PERMIT – Repair

**ON-SITE SEWAGE DISPOSAL SYSTEM
HOWARD COUNTY HEALTH DEPARTMENT
BUREAU OF ENVIRONMENTAL HEALTH**

ADDRESS: 2555 Sand Hill Rd PROPERTY OWNER: Chris Hayes

SITE INSPECTION SHEET

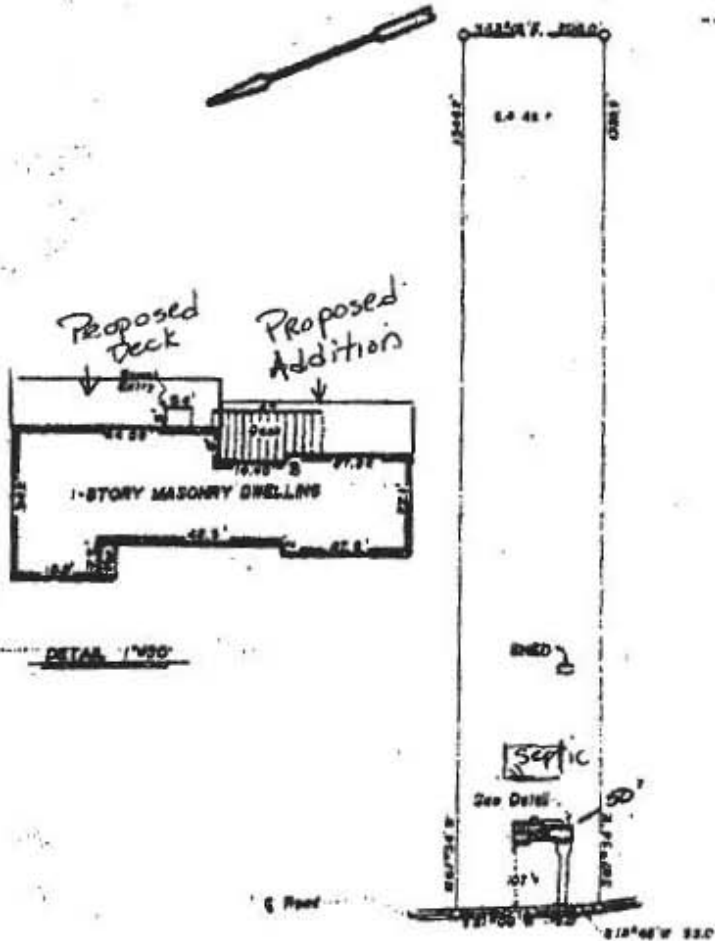
9/23/08
proposed
addition OK
as shown -
shall not impact
existing septic
system (OK)

LOCATION DIAGRAM

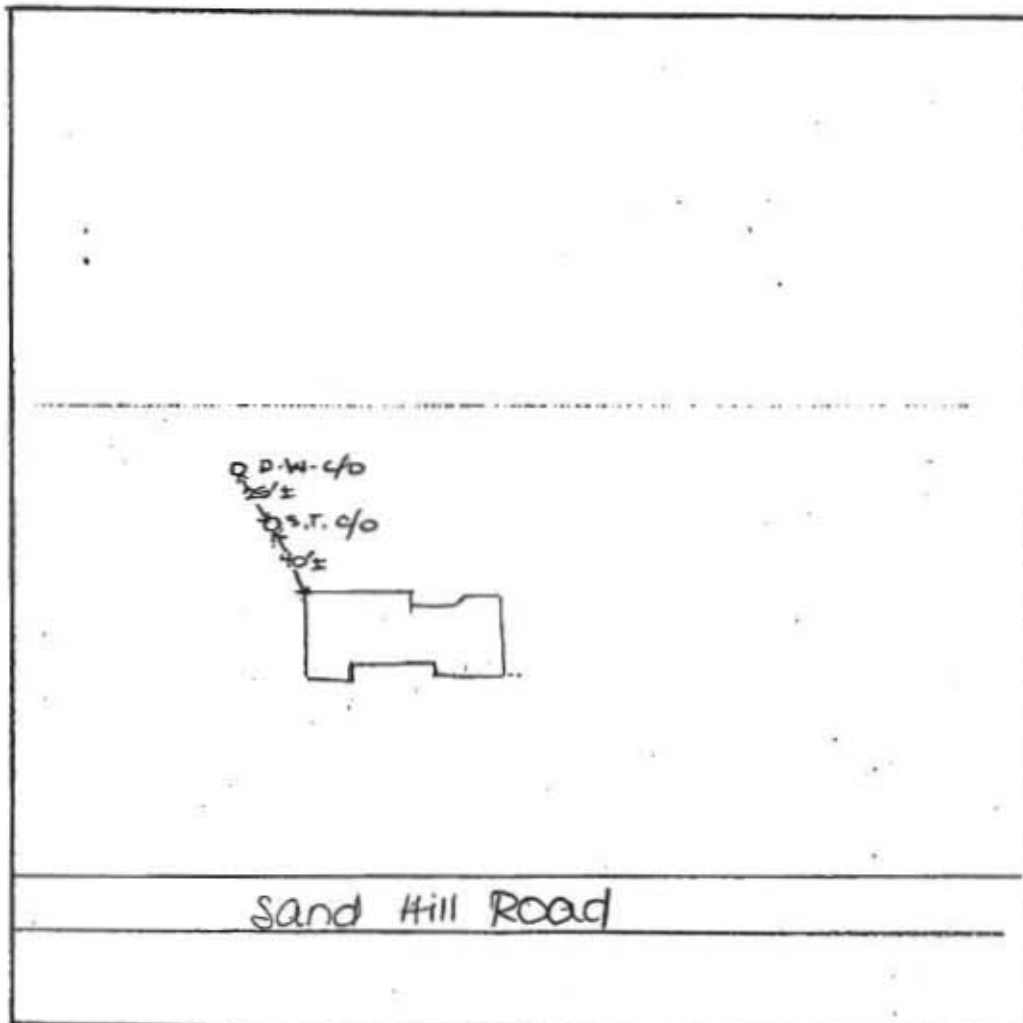
PROPOSAL: Application received for building permit for addition to existing dwelling - No Health Dept. records on file.

COMMENTS: met owner @ site - confirmed location of existing septic system. Location of septic system not in conflict w/ proposed addition. Property is served by public water. OK to proceed w/ building permit approval.
